Item Name: Crosstube Aft

DART SERVICE INSTRUCTION

DRAWING NO. D212-664-241	TITLE CROSSTUBE ASSY (205/212 HI AFT)	REV. D	DART AEROSPACE LTD ENGINEERING ORDER		D.E.O. NO. D212-664-241-D-1	SHEET NO. SHEET 1 OF 2	SCALE NTS
DRAWN	CHECKED	MFG. APPR.	APPROVED	DE APPR.			
DATE 11.04.07	DATE 11.04.11	DATE 11.04.12	DATE 11/04/12	DATE 11.04.12

DRAWING NO. D212-664-241	TITLE CROSSTUBE ASS'Y (205/212 HI AFT)	REV. D	DART AEROSPACE LTD ENGINEERING ORDER		D.E.O. NO. D212-664-241-D-2	SHEET NO. SHEET 1 OF 1	SCALE NTS
DRAWN 97	CHECKED ASS	MFG. APPR. [Signature]	APPROVED [Signature]		DE APPR. [Signature]		
DATE 11.07.15	DATE 11.07.20	DATE 11.07.21	DATE 11/27/21		DATE 11.07.21

FIGURE 1: SUPPORT INSTALLATION

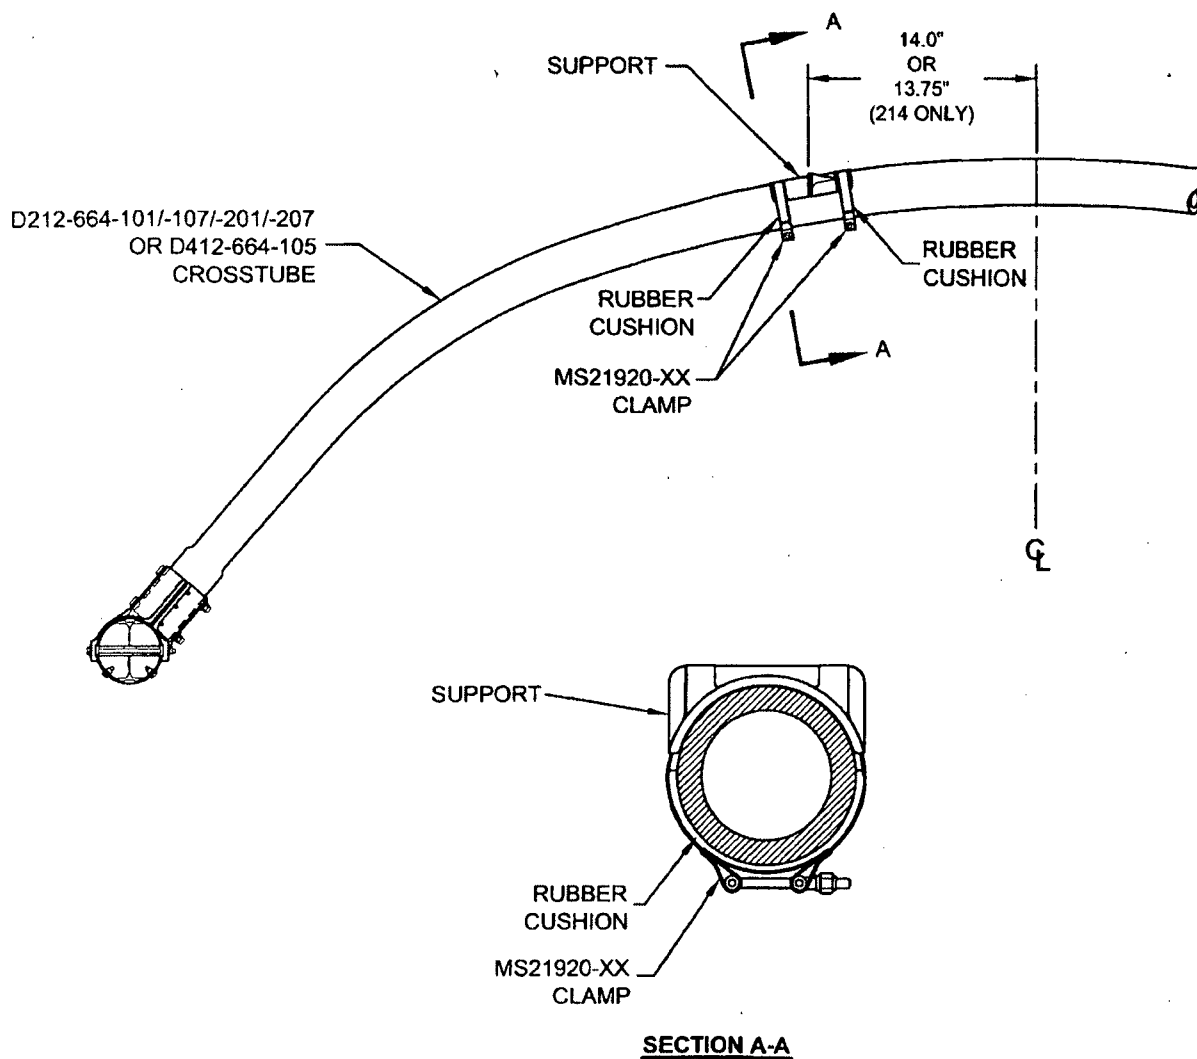
The supports on the following crosstubes are now installed using Proseal instead of Magnobond:

For the crosstubes listed above, section 32.4 of ICA-D212-664 is amended as follows. Use Figure 1 of this service instruction and Figures 32-2 to 32-9 of ICA-D212-664 for further reference. For crosstubes of an earlier change number, it is recommended that if the supports are removed, the supports should be reinstalled using the procedure listed below.

- 32.4.1 Locate the area on the crosstube for installation of support (see Figure 1 of this service instruction). For D212-664-101/-107/-201/-207 and D412-664-105 crosstubes, the outward face of the support tabs should be 14.0" (355mm) from the crosstube center for 204/205/210/412/UH-1 aircraft. For installation on 214B/B-1 aircraft, the outward face of the support tabs should be 13.75" (349mm). Ensure paint finish of crosstube is intact; touch up as required per Chapter 5 (5.3.9) of ICA-D212-664.

- 32.4.2 If present, remove any paint/primer on bottom of supports. Abrade mating surfaces of support and crosstube with 400-grit sandpaper. Saturate a clean cloth with MEK or 4105S Wash'n'Wipe Degreaser or equivalent and wipe until there is no residue.

- 32.4.3 Ensure a layer of 3M Scotch-Weld 2216 B/A Epoxy Adhesive is on the bottom of the support. If required, either apply or touch-up support to have a 0.03" to 0.05" thick layer of adhesive over the entire mating surface. Allow supports to cure for 24 hours.

- 32.4.4 Abrade mating surfaces of support (after cure) and crosstube with 180-grit sandpaper. Saturate a clean cloth with MEK or 4105S Wash'n'Wipe Degreaser or equivalent and wipe until there is no residue.

- 32.4.5 Apply a 0.04" to 0.07" thick layer of Proseal 890 Class B or AMS-S-8802 Class B sealant underneath applicable support and install support as shown in Figure 1 of this service instruction.

- 32.4.6 Install the clamps opposite to crosstube support as shown in section A-A of Figure 1. Install rubber cushions underneath each clamp around the bottom circumference of the crosstube up to the crosstube centerline. Torque clamps 80-100 in-lb (9.0-11.3 Nm). It is acceptable to use smaller or larger sized MS21920-XX clamps than those listed in ICA-D212-664, ensure that after torquing the clamps per this instruction, the nuts are in safety but not bottomed out.

- 32.4.7 Prior to installing crosstube on aircraft, allow supports to cure for 72 hours and recheck torque on clamps.

**D212-664-241/-241B
ASSEMBLY DETAIL**

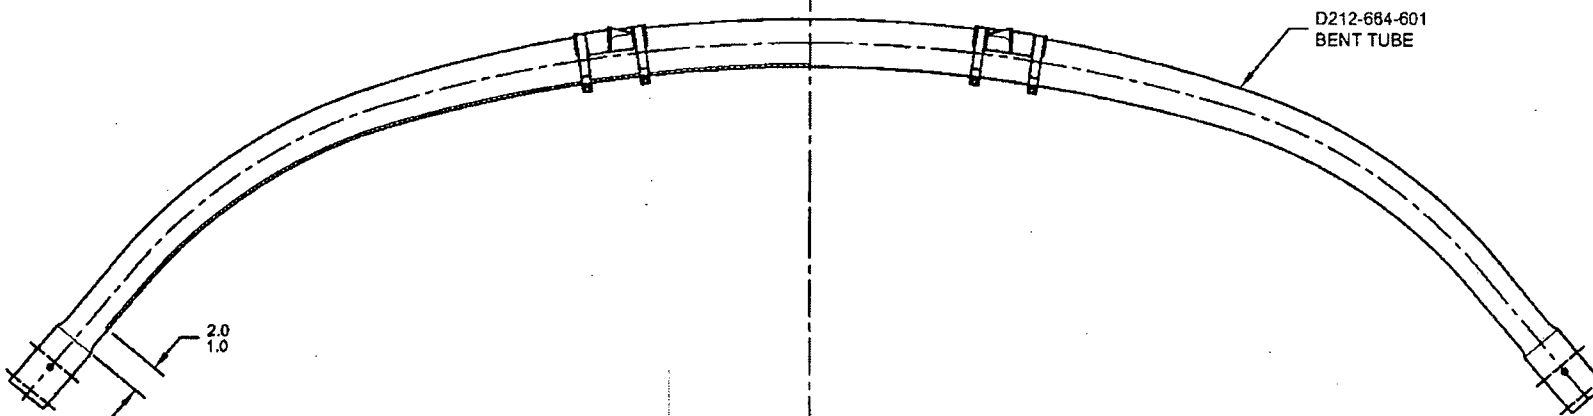
ADD AN INSPECTION WINDOW TO UNDERSIDE OF CROSSTUBE.

NOTES 2 OF SHEET 1 IS AMENDED AS FOLLOWS:

- 2) FINISH: CHEMICAL CONVERSION COAT PER DART QSI 005 4.1
PRIME INSIDE AND OUTSIDE PER DART QSI 005 4.2
MASK UNDERSIDE OF CROSSTUBE AS SHOWN (HATCHED AREA) AND
PAINT OUTSIDE PER DART QSI 005 4.2
REMOVE MASKING AND APPLY CLEAR COAT

MASK AREA PRIOR TO PAINTING,
REMOVE MASKING AFTER PAINT
AND APPLY CLEAR COAT

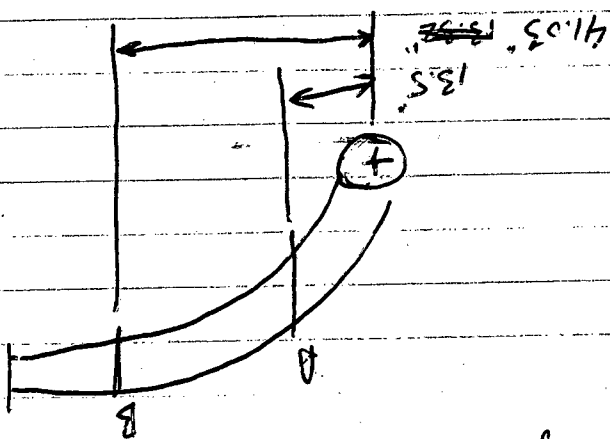
REPLACE MAGNOBOND WITH PROSEAL.

NOTE 12 & 15, SHEET 1 IS AMENDED AS FOLLOWS:

- 12) TO INSTALL D2940-1 SUPPORT: ABRASE MATING SURFACE OF SUPPORT AND CROSSTUBE WITH 180-GRIT SANDPAPER AND REMOVE RESIDUE WITH MEK (OR EQUIVALENT). APPLY A 0.04" TO 0.07" THICK LAYER OF PROSEAL 890 CLASS B-2 (OR AMS-S-8802 CLASS B-2) SEALANT TO MATING SURFACE OF SUPPORT.
- 15) TORQUE CLAMPS 80 TO 100 IN-LB. ENSURE AT LEAST 1.5 THREADS SHOWING IN SAFETY AND THAT NUT HAS NOT BOTTOMED-OUT AFTER TORQUING. **PRIOR TO PACKAGING, RE-CHECK TORQUE ON CLAMPS AFTER PROSEAL 890 SEALANT HAS CURED FOR 72 HOURS.**

- 12) INSTALL D2940-1 SUPPORT USING 0.03" TO 0.06" THICK LAYER OF MAGNOBOND 6398 TO THE SURFACE OF D2940-1 THAT WILL BE IN CONTACT WITH THE CROSSTUBE PER QSI 015. LET CURE FOR 12 HOURS AFTER INSTALLATION AND PRIOR TO PACKAGING.
- 15) TORQUE CLAMPS 80 TO 100 IN-LB. ENSURE AT LEAST 1.5 THREADS SHOWING IN SAFETY AND THAT NUT HAS NOT BOTTOMED-OUT AFTER TORQUING.
